ADDENDUM NO. 01

RANKIN TRAILS AMPHITHEATER AND BASEBALL PARK

Rankin County, Mississippi

WBA Proj. # 2215/2315

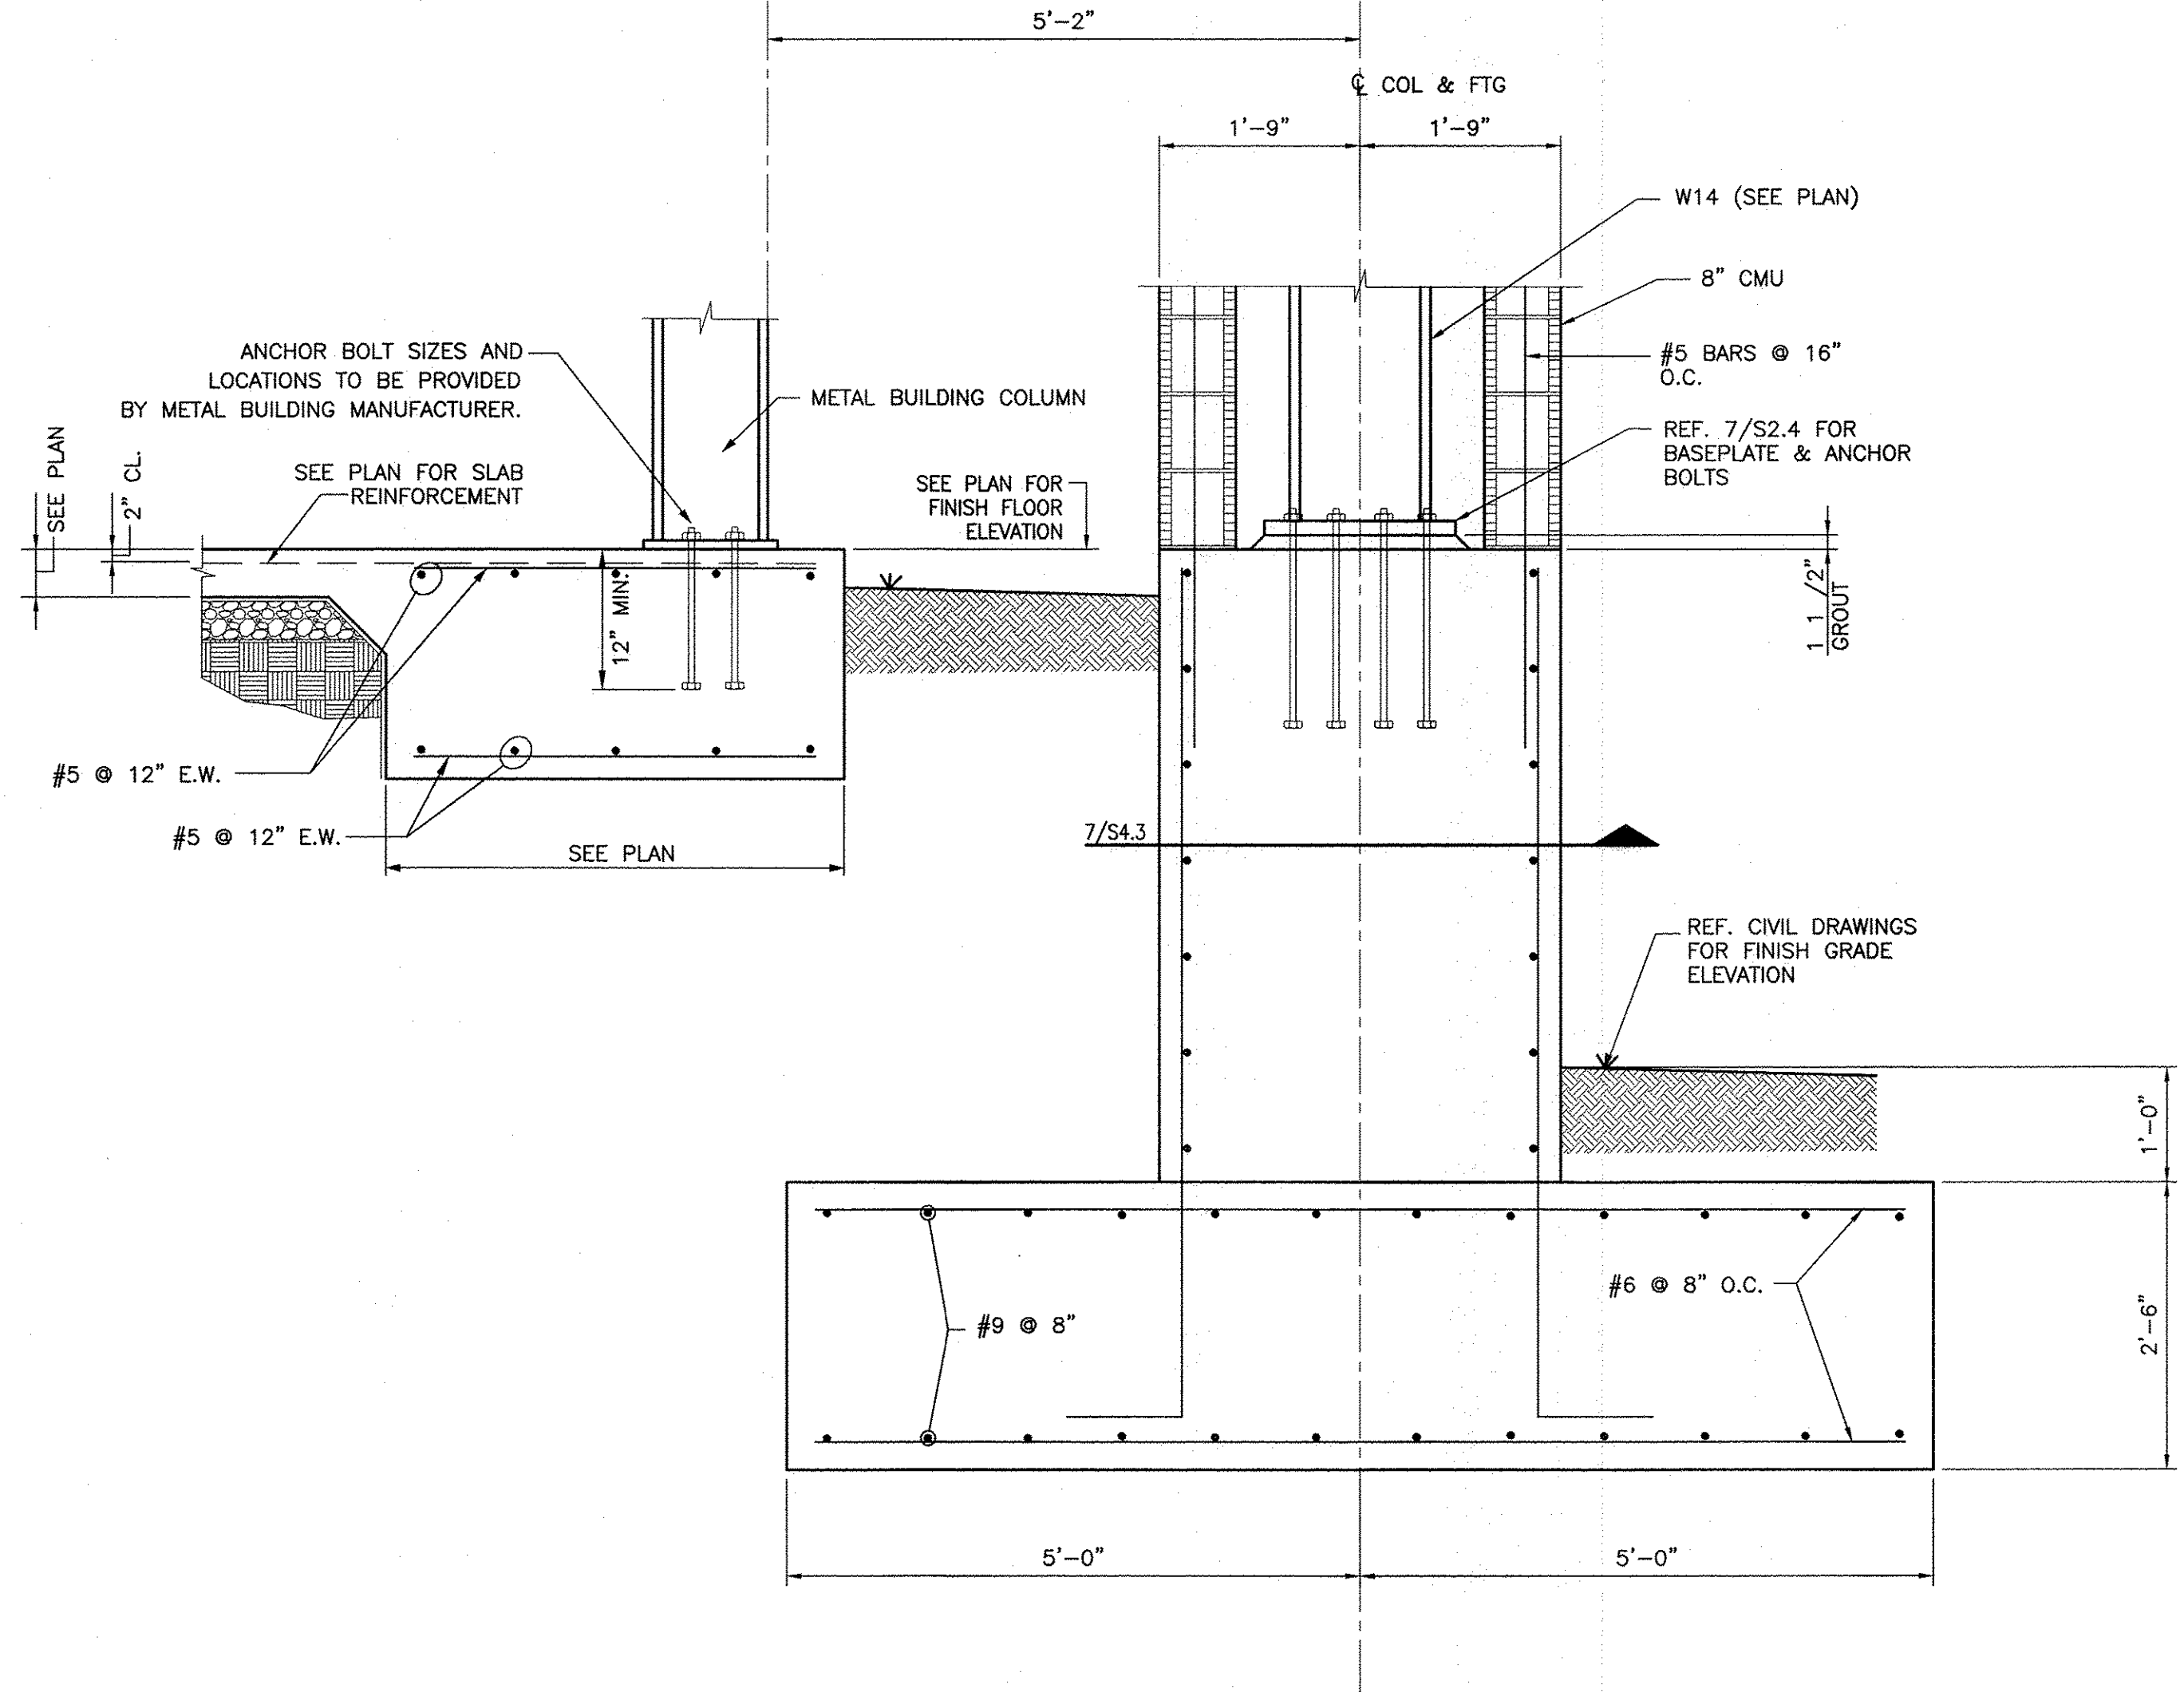
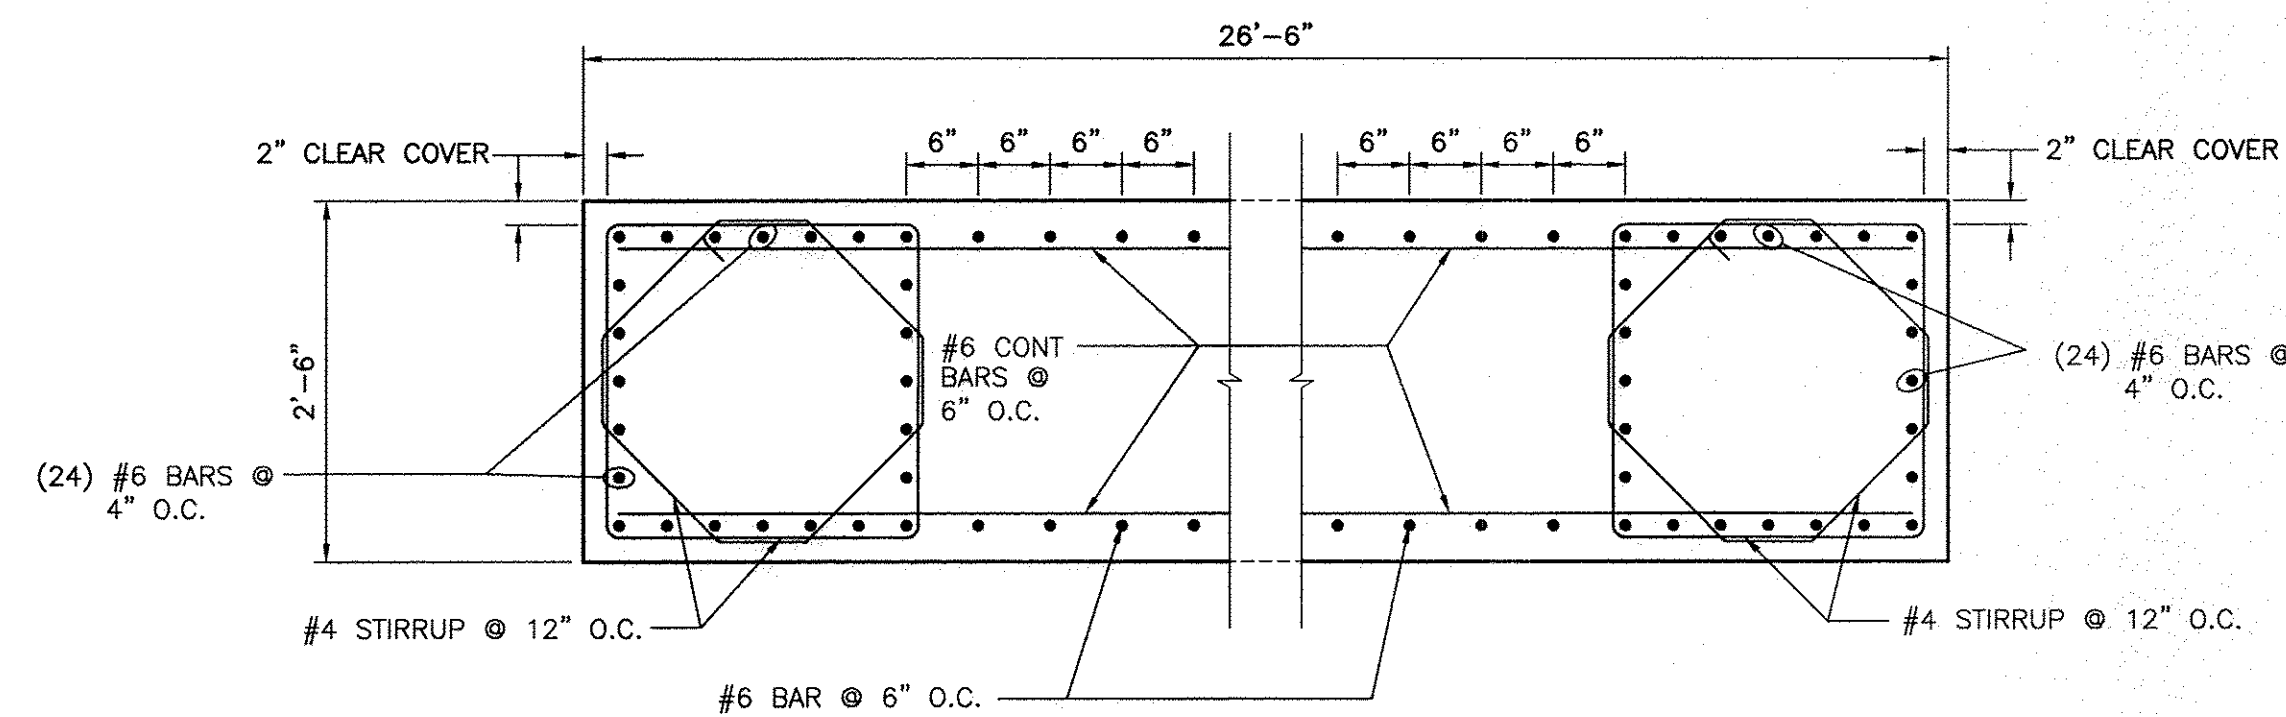
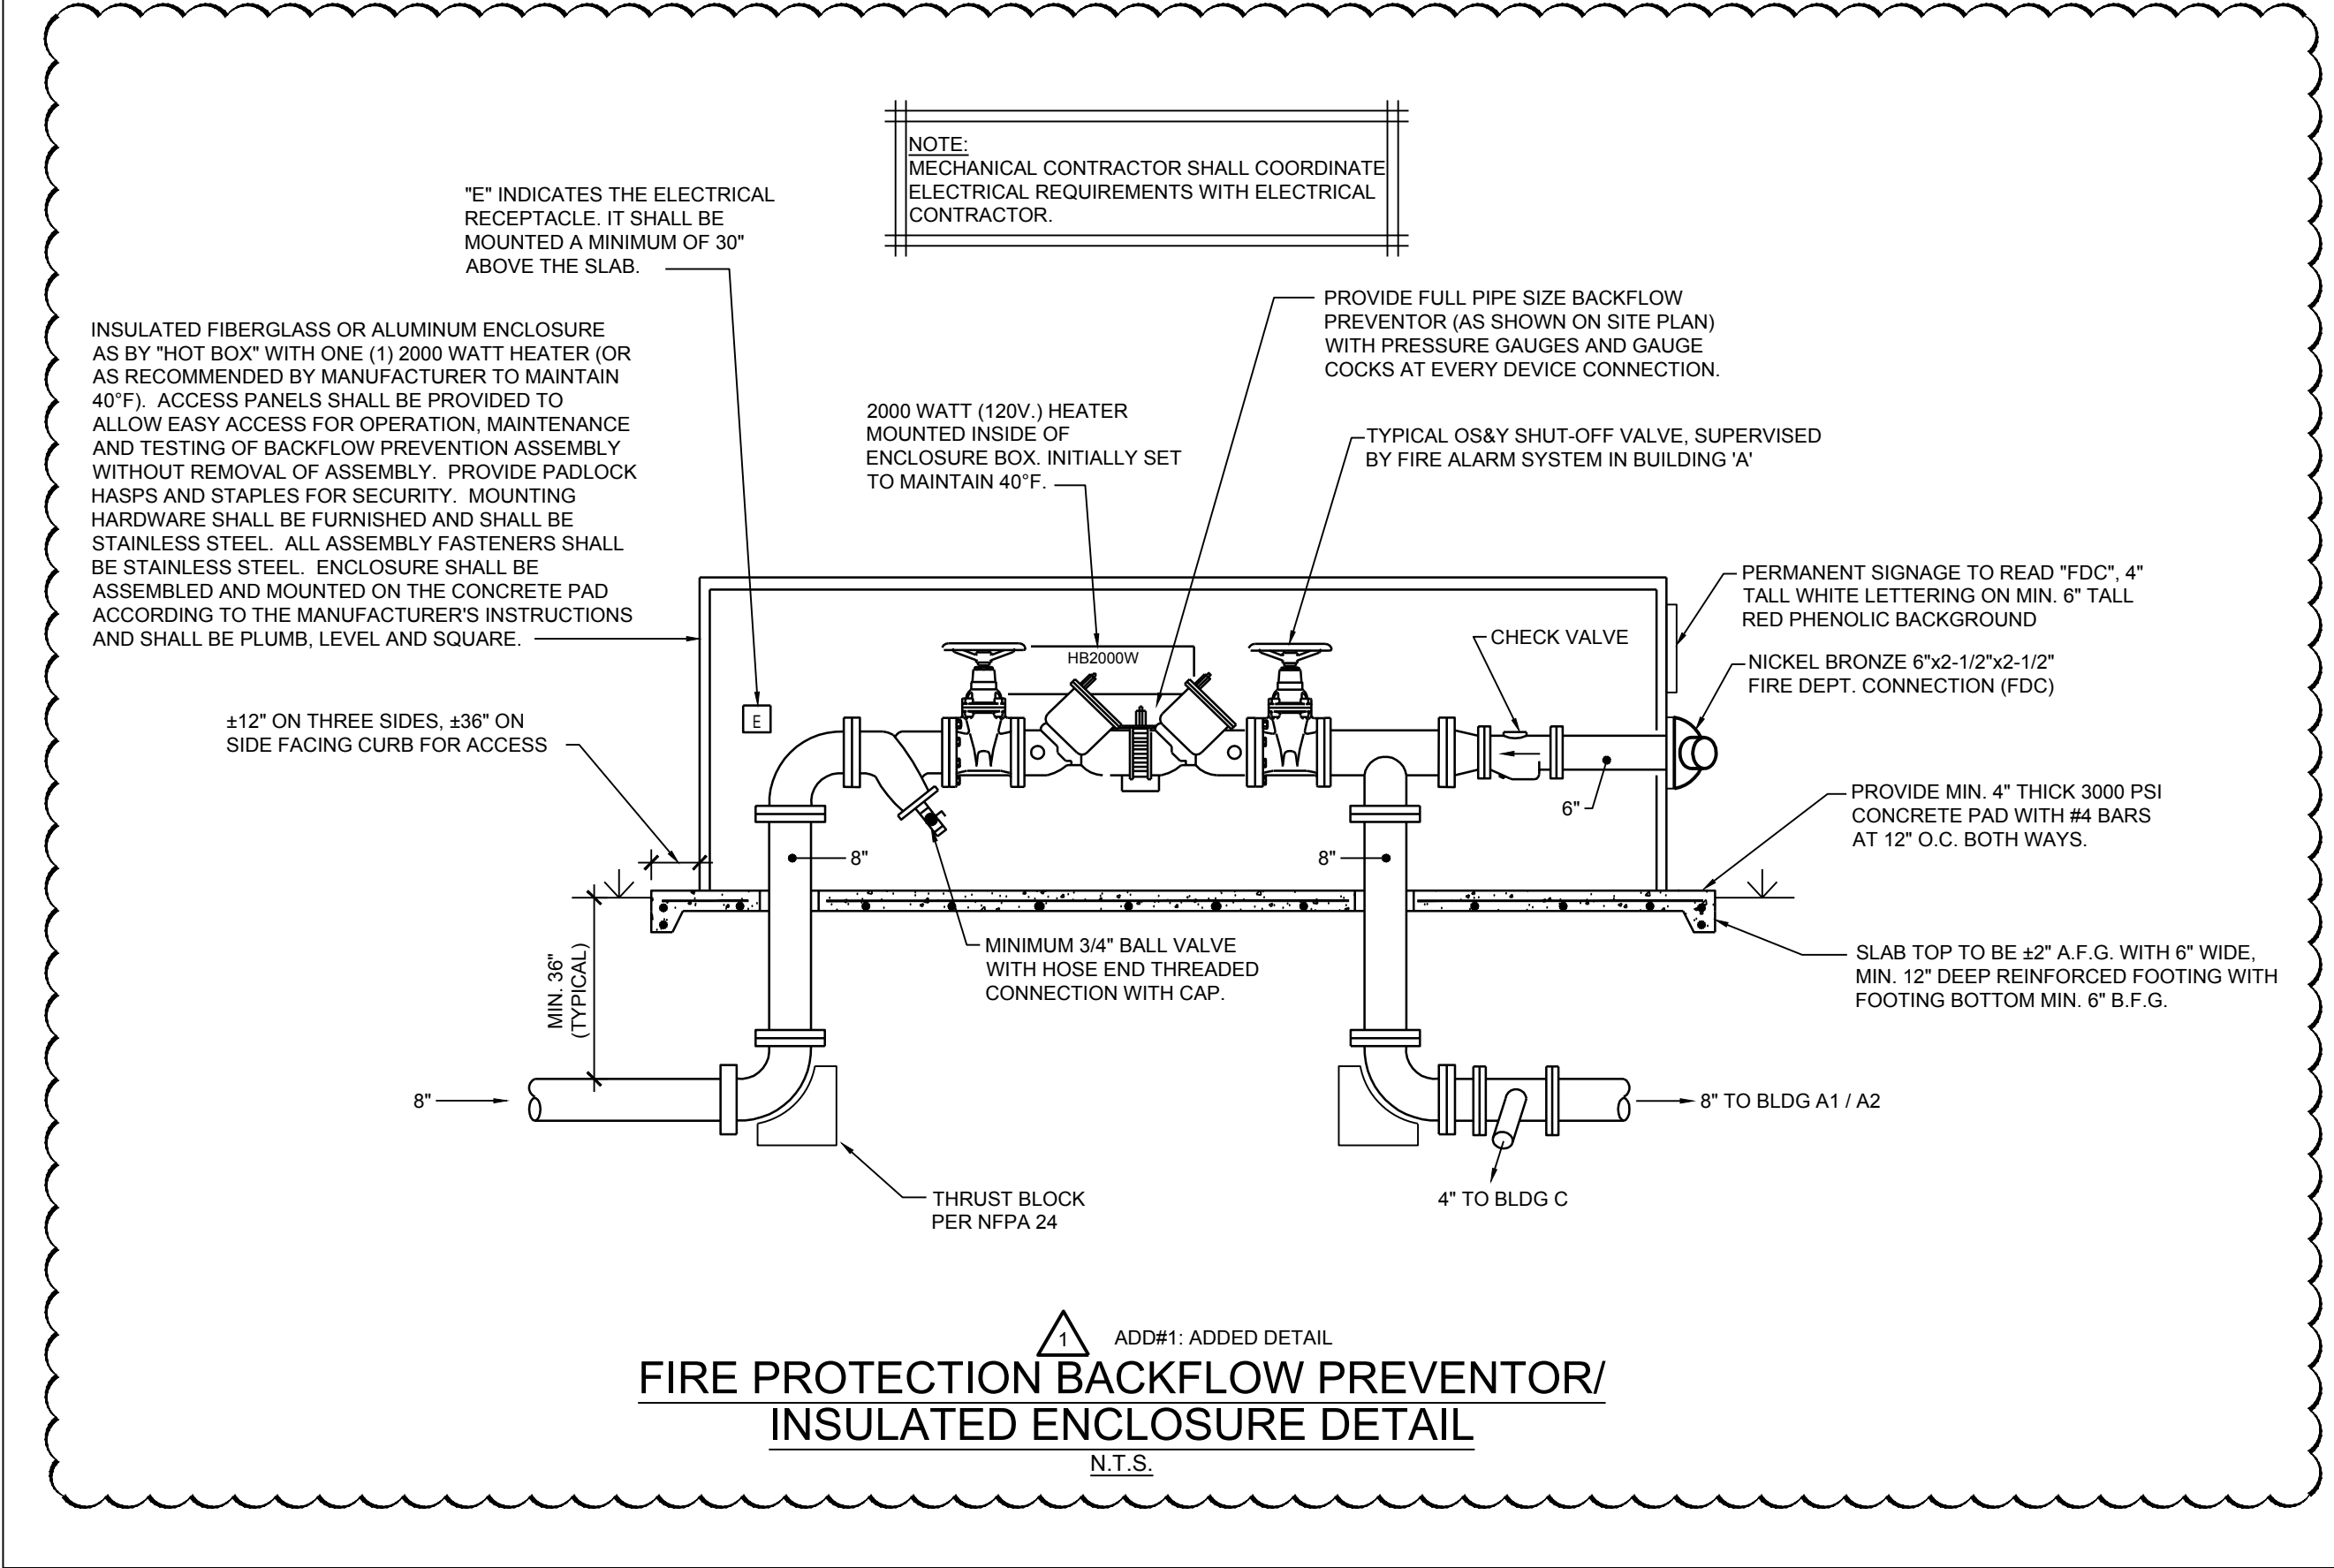
- ITEM NO. 15** **SHEET S3.1 ELEVATIONS**
ADD missing text, per enclosed revised sheet S3.1.
- ITEM NO. 16** **SHEET S4.3 SECTIONS**
REVISE wall reinforcement extents, per enclosed revised sheet S4.3.
REVISE wall reinforcement, per enclosed revised sheet S4.3.
REVISE embedded bolt size and depth, per enclosed revised sheet S4.3.
ADD roof deck detail, per enclosed revised sheet S4.3.
